Re: St. Lucie Plant Unit 2
Docket No. 50-389
Renewed Facility Operating License No. NPF-16

Response to NRC Request for Additional Information (RAI) Regarding Extended
Power Uprate License Amendment Request

**Response to NRC Nuclear Performance and Code Branch
Request for Additional Information**

SNPB-16

The variables listed in Table 2 are plotted as functions of time in Figures 1 through 9 for the 1.0 DEG/PD break, in Figures 10 through 18 for the 0.8 DEG/PD break, and in Figures 39 through 47 for the 0.4 DEG/PD break.

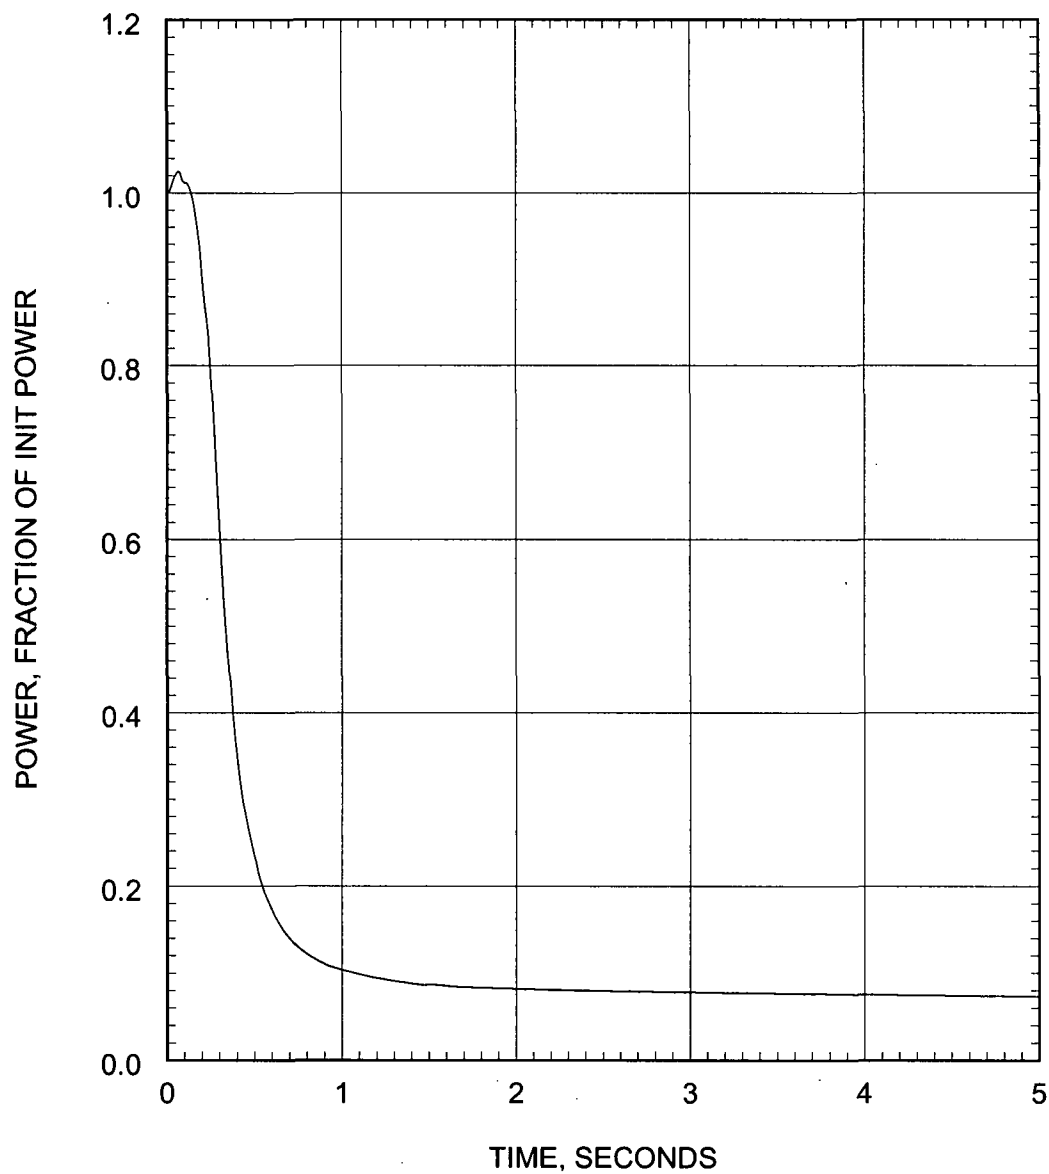
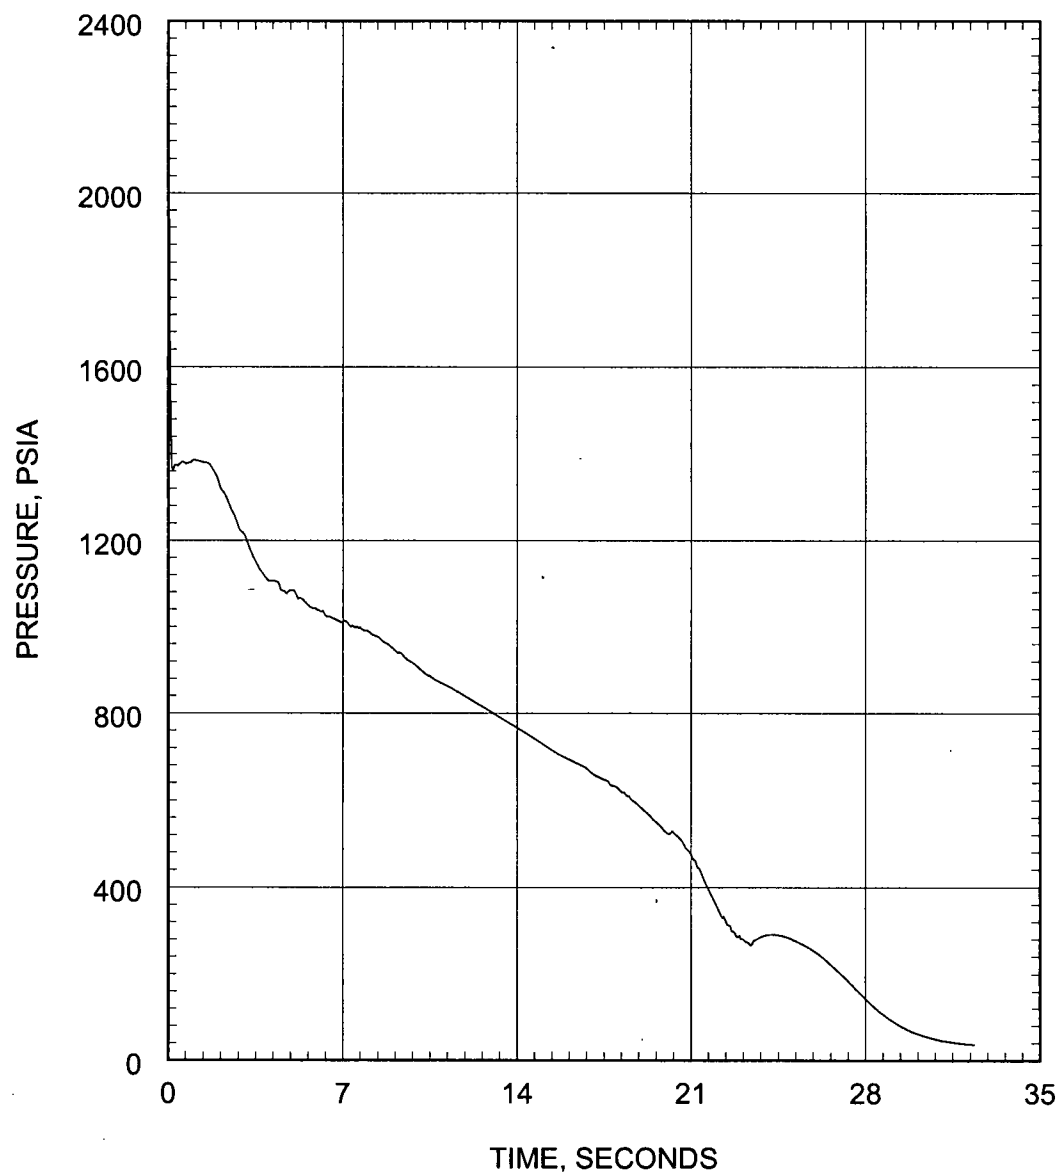
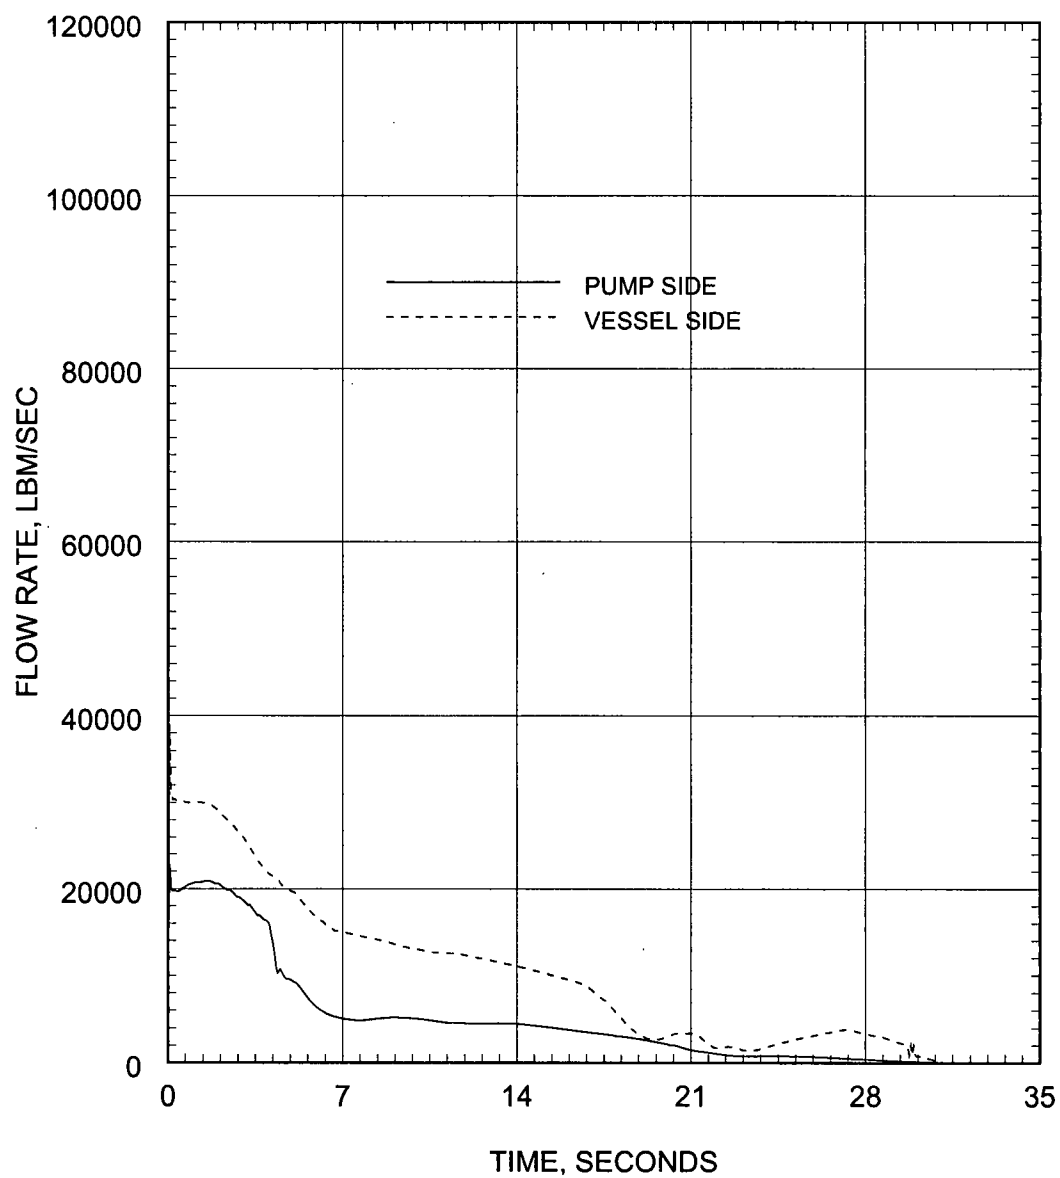
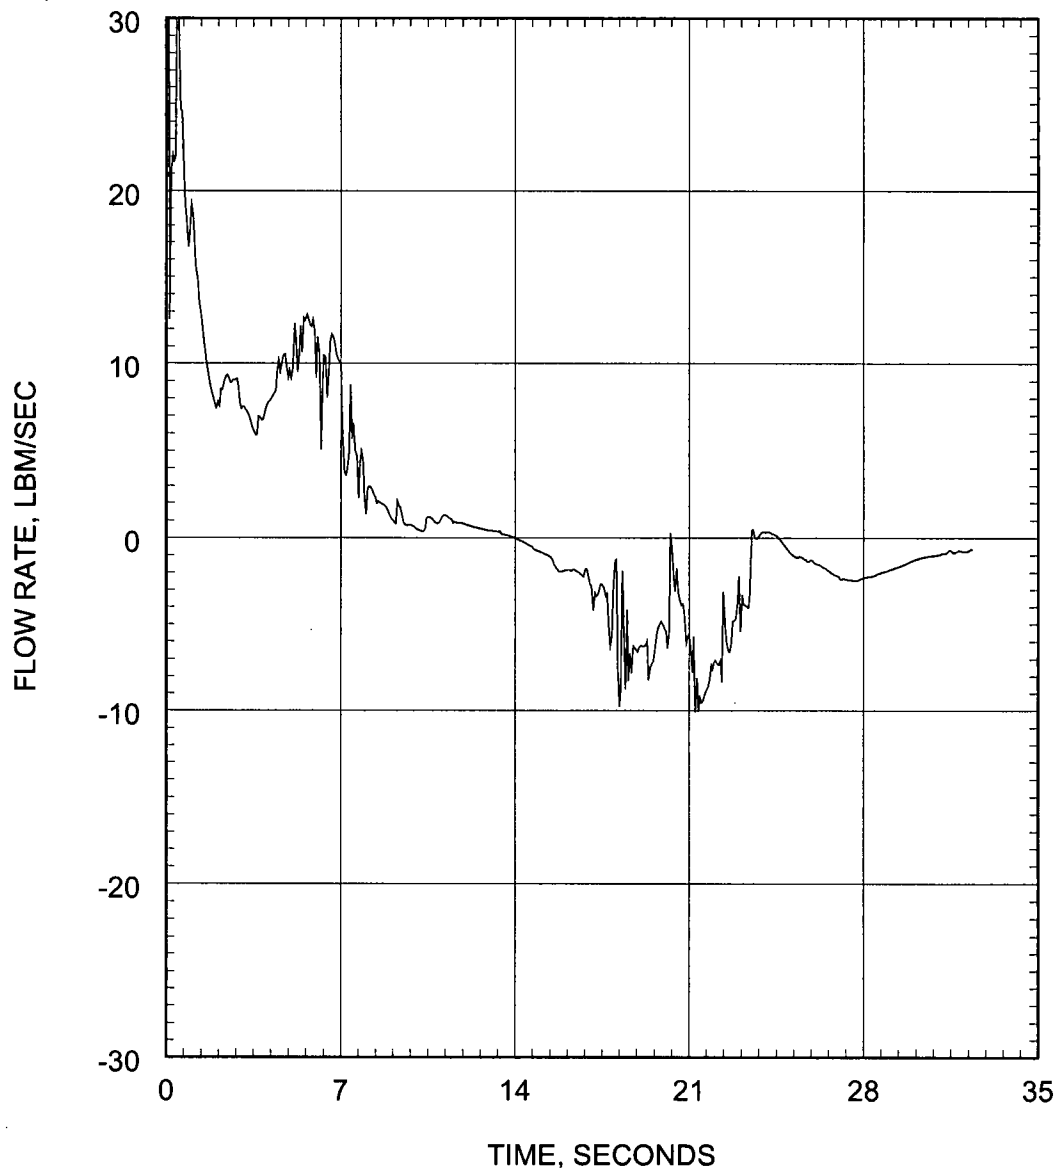
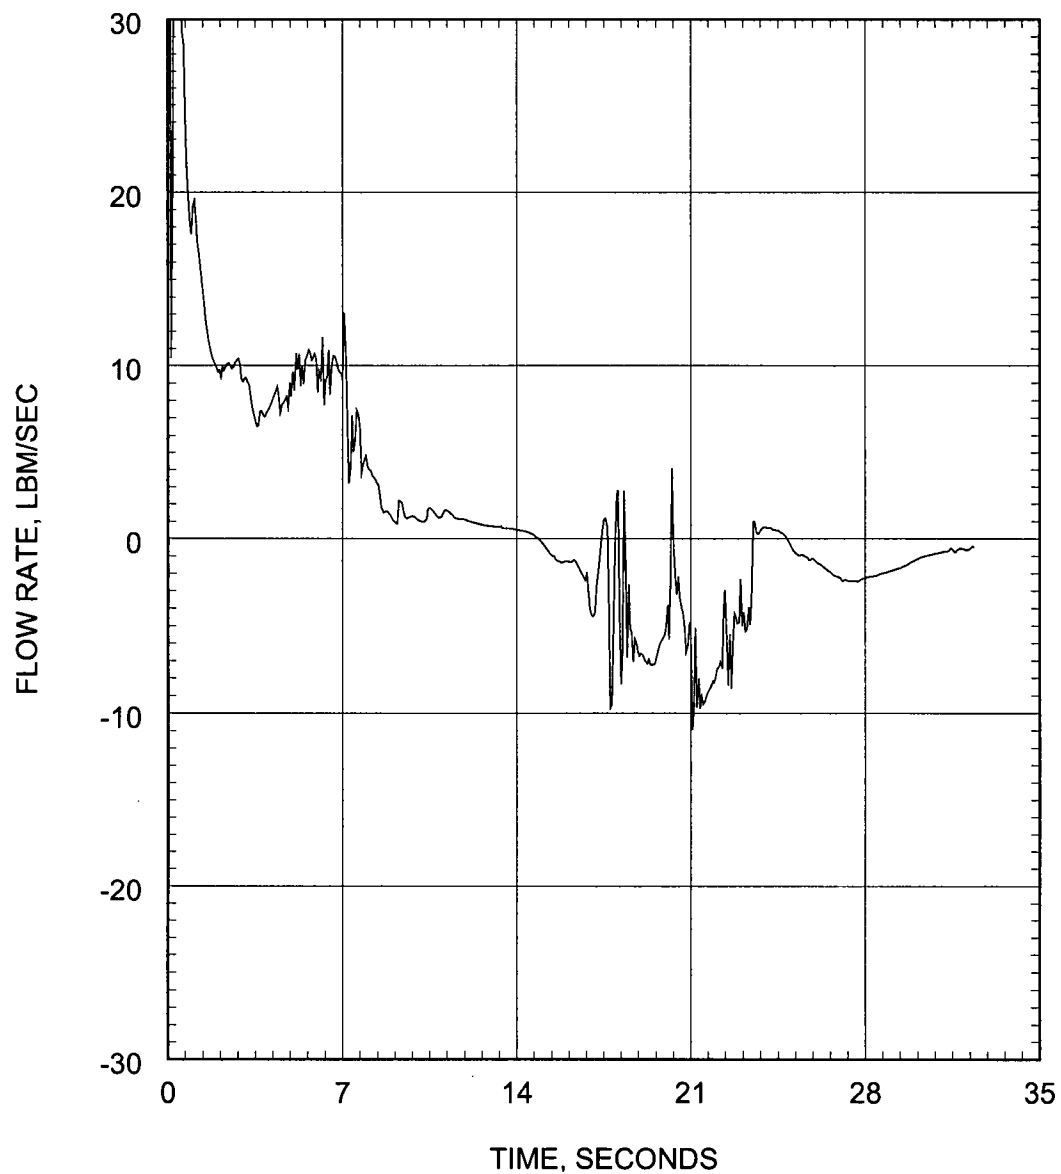
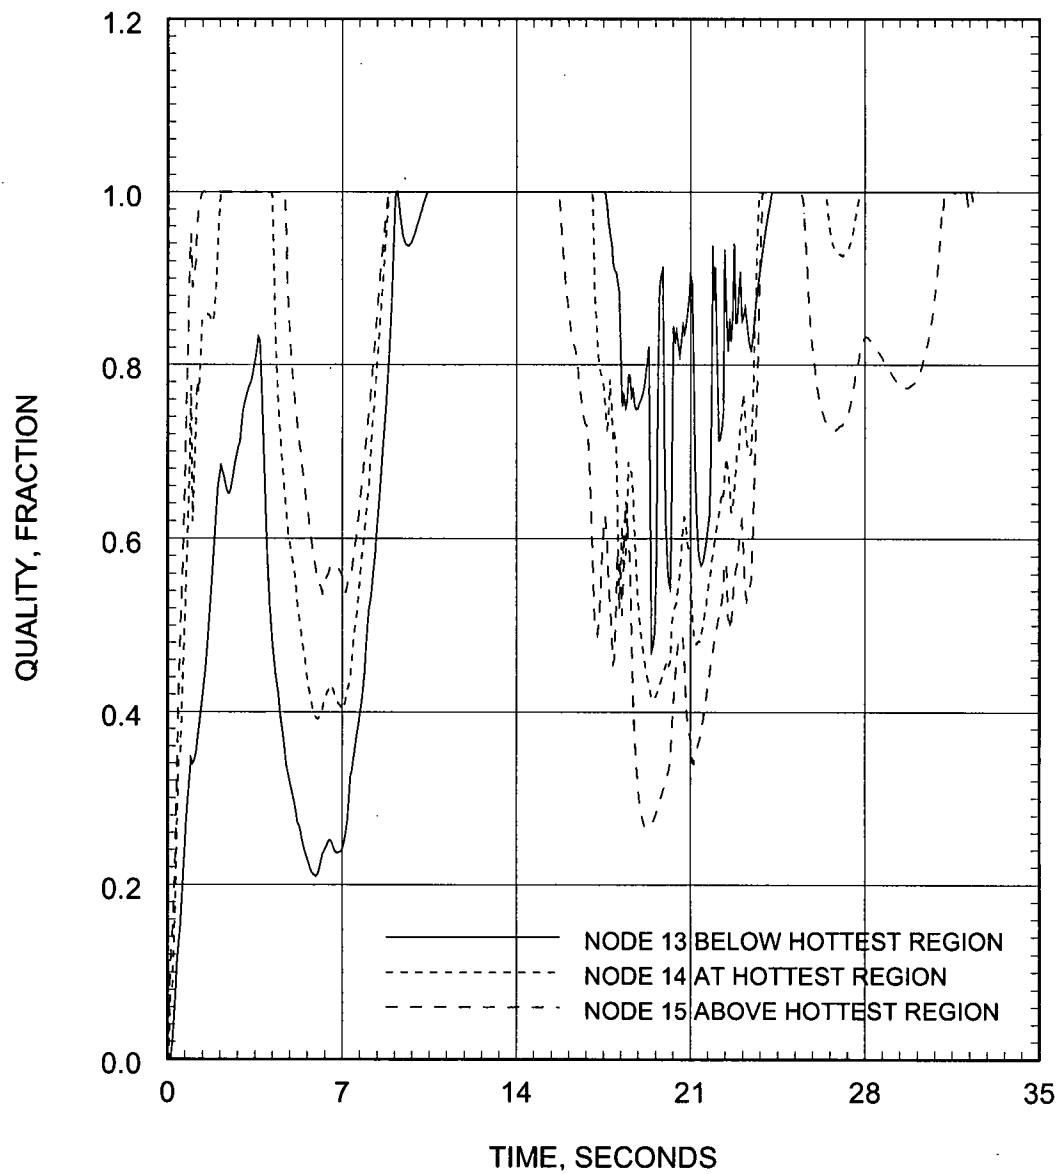
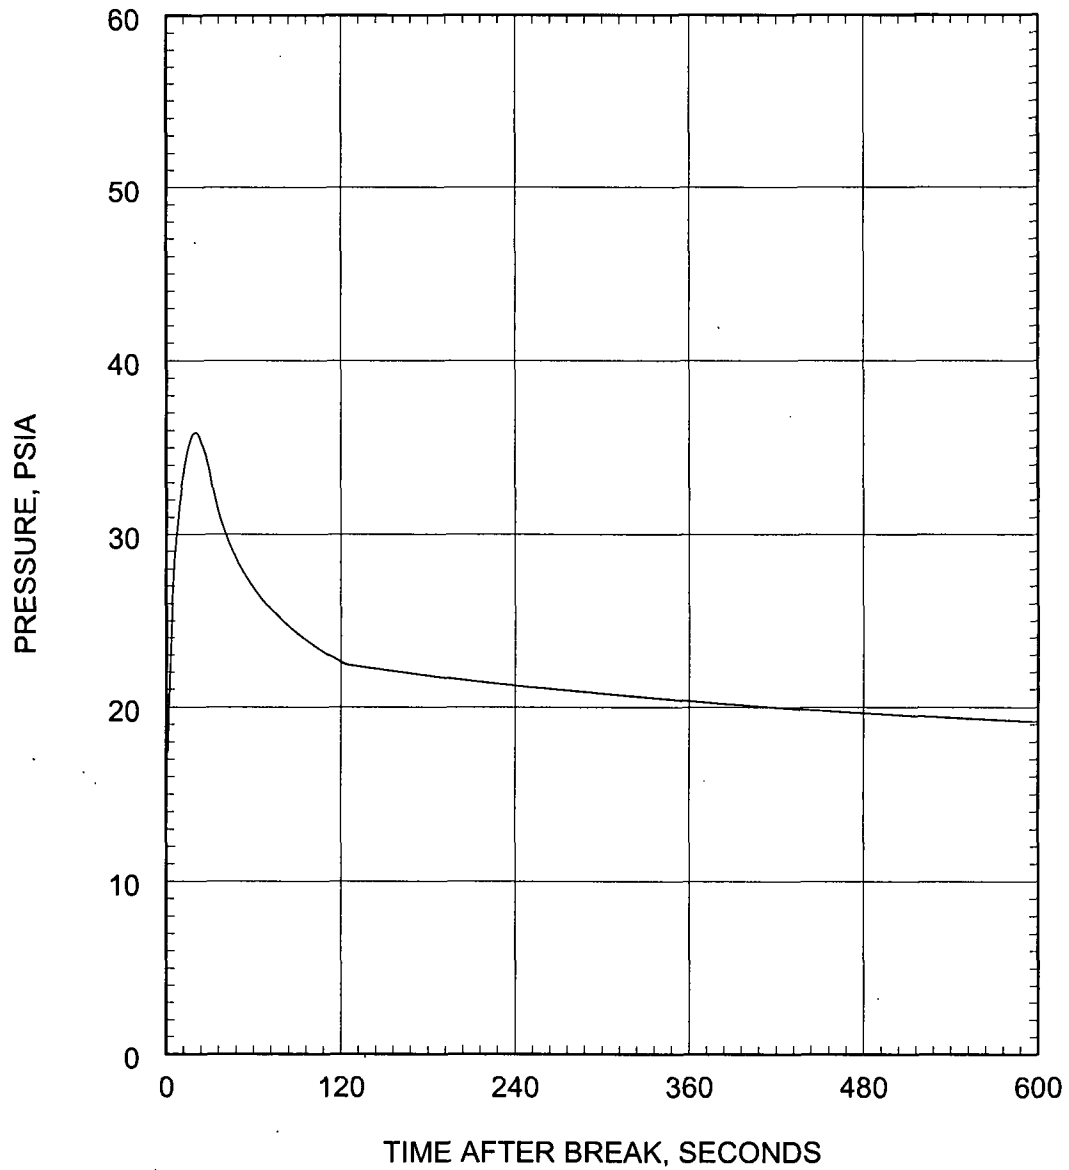
Please provide the results of the seismic LOCA loads analysis for the limiting break. Identify the maximum hot channel deformation/flow area reduction, the maximum hot bundle flow area reduction, the peak linear heat rate for the hottest rod in the assembly undergoing maximum deformation. Also, provide the linear heat rate for the bundle containing the rod with the max deformation. The analysis should provide the plots typical of the limiting large break LOCA analysis given in a chapter 15 analysis.
